**Re: DEP Request for Additional Information
Blacklog Creek Crossing 16" Horizontal Directional Drill Location (S2-0154-16)
Permit No. E31-234
Shirley Township, Huntingdon County**

Mr. Scott Williamson
Response to DEP Comments on S2-0154-16
May 22, 2019
Page 9

Figure 1 - Topographic Basemap
 Shirley Township, Huntingdon County, PA
 Project No. 096302011

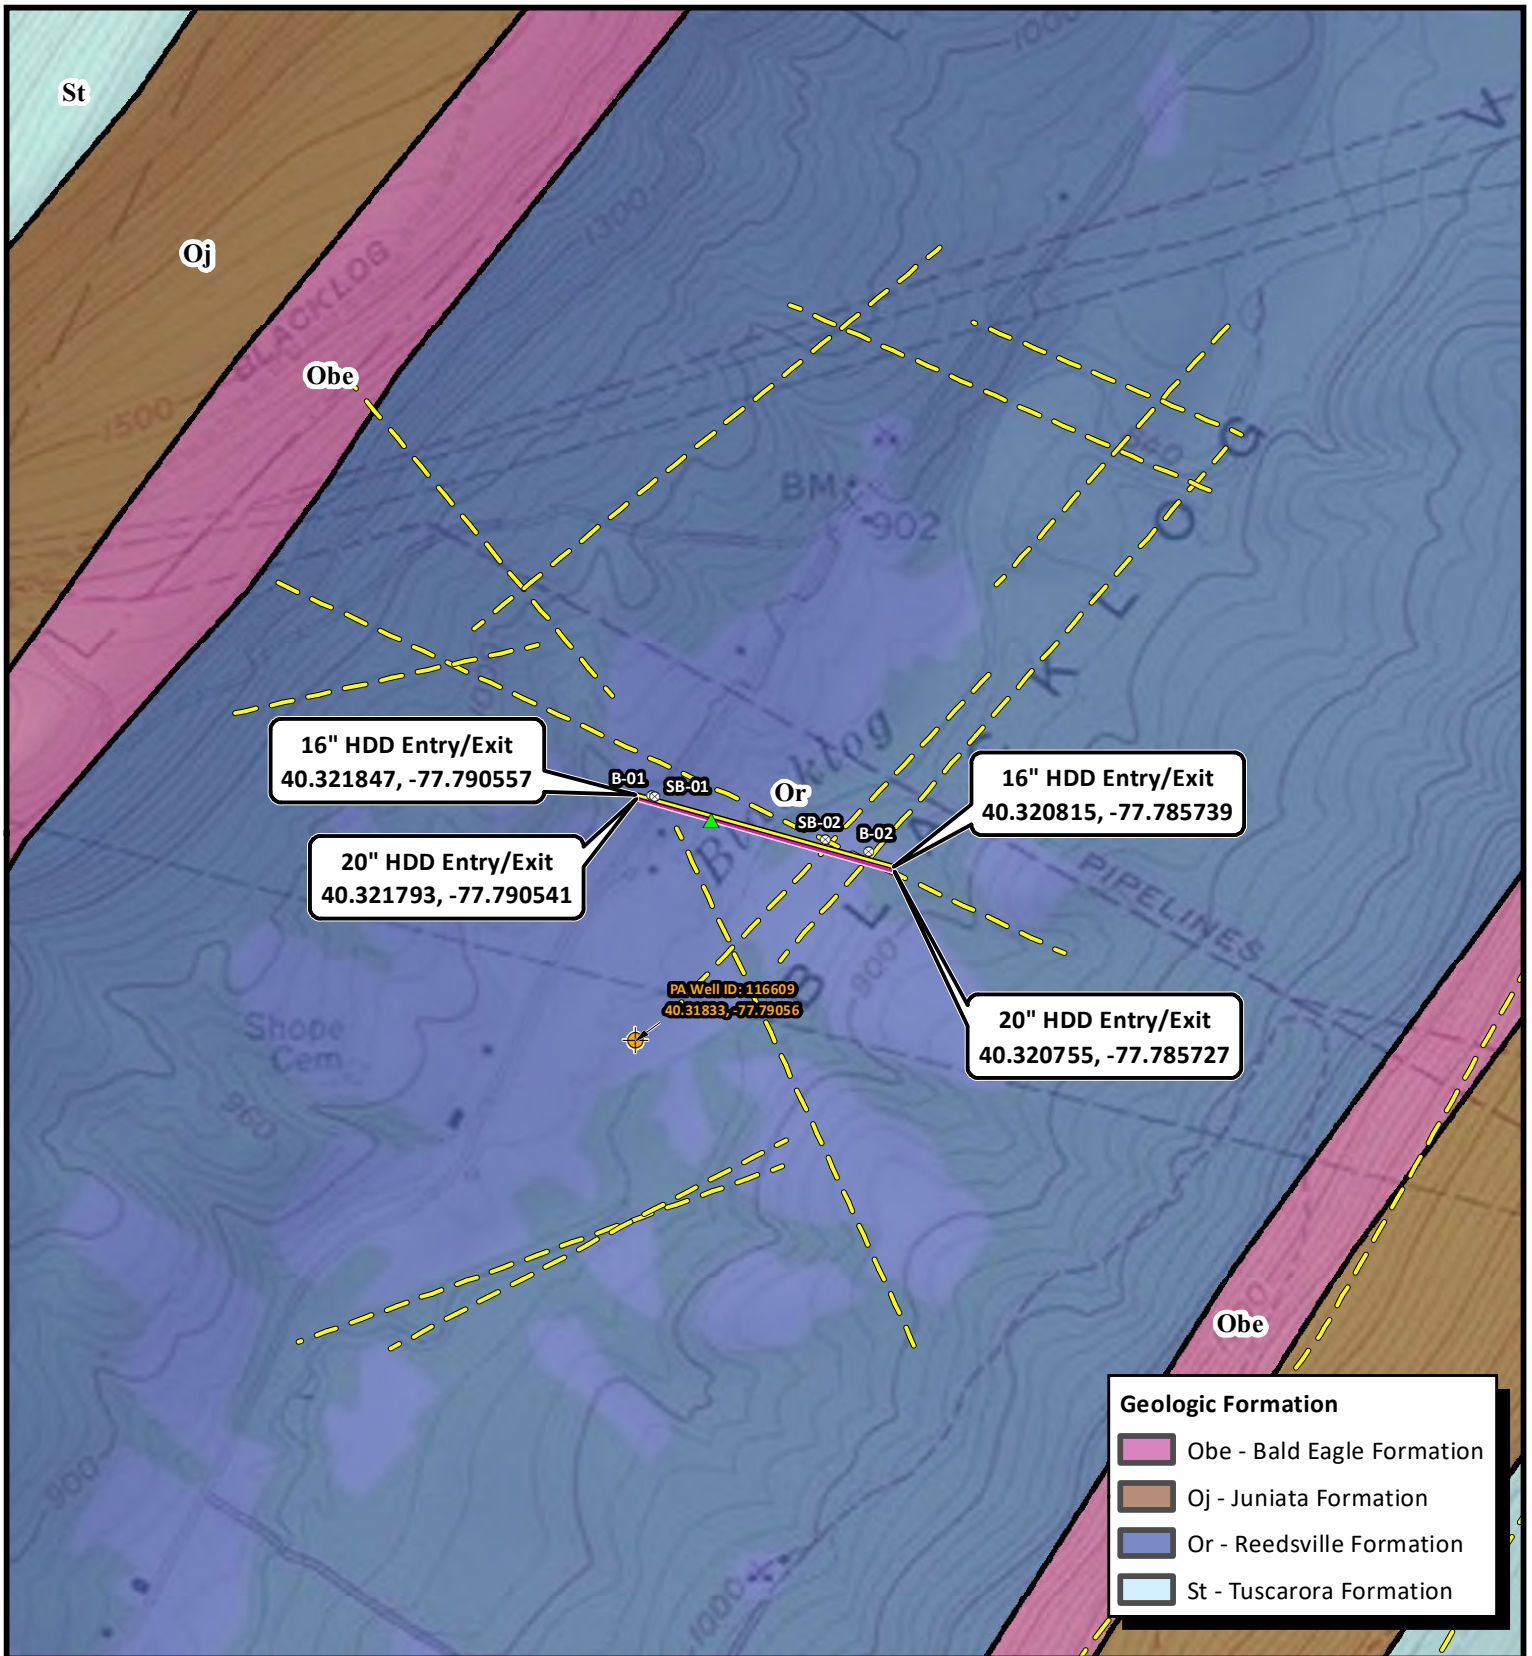
- d. It is unclear from the narrative discussions which direction the HDD will proceed. Please confirm the drilling direction is West to East, as is indicated in Figures 1-3.**

The 16-inch HDD will be drilled from east to west, or from low elevation to high elevation.

Well Location Map
HDD# PA-HU-0106.0000-RD
Huntingdon County, PA.

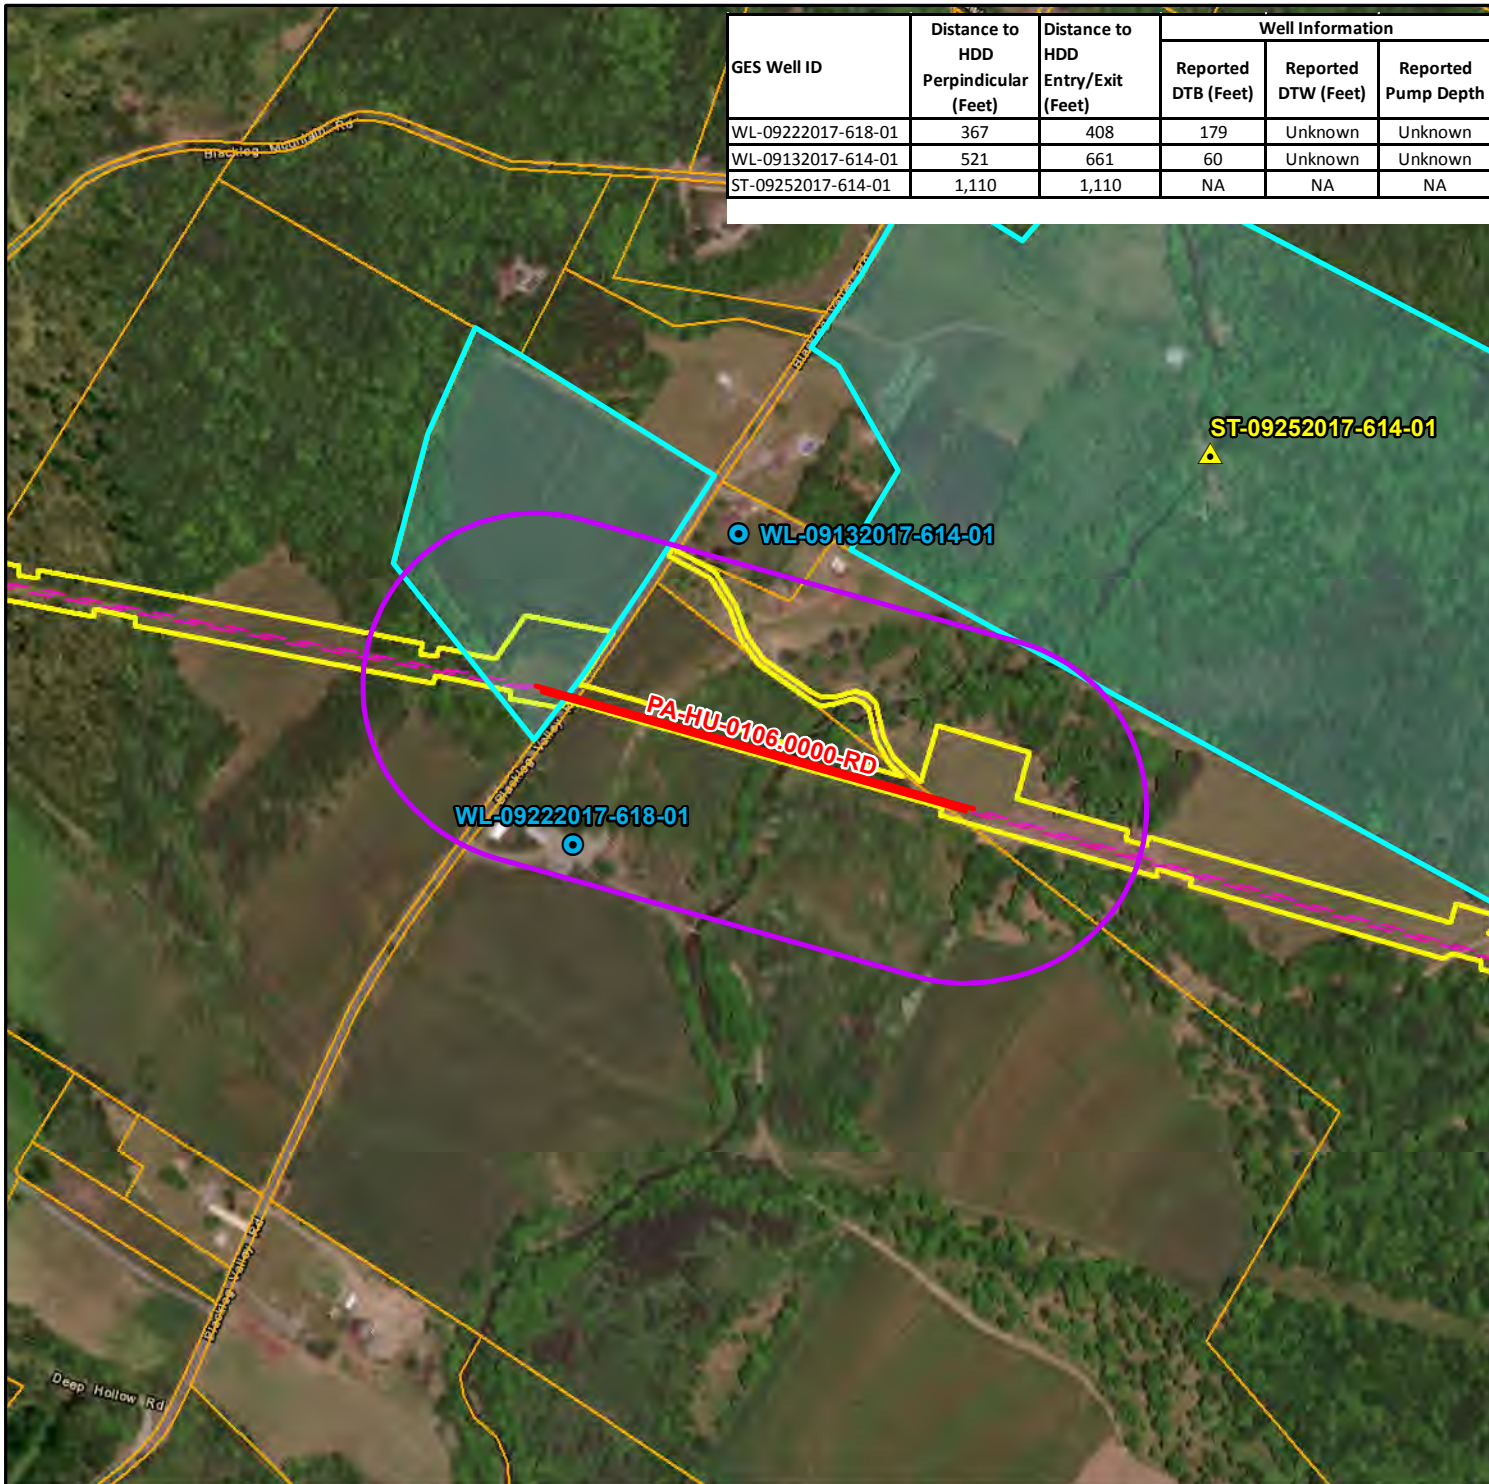
- j. Attachment 3 Well Location Map contains a location labelled "GES Stream Testing Location", with GES well ID ST-09252017-614-01. Is this the same location described in Section 3.0 Hydrogeology of the Geologic Report as a spring? Was the spring sampled? If yes to either question, use and discuss any applicable and relevant data in the re-evaluation.**

The GES 'Stream Testing Location' and the "spring" identified in Section 3.0 of the Geology and Hydrogeologic Evaluation Report are the same location. With the exception of iron, none of the parameters typically identified in samples impacted by drilling fluids (i.e., turbidity, total suspended solids, iron and manganese) were identified in this sample at concentrations higher than the Department's established primary and secondary drinking water standards (MCLs/SMCLs). However, only the iron results from the pre-construction sampling event were detected at a concentration greater than the secondary drinking water standard.
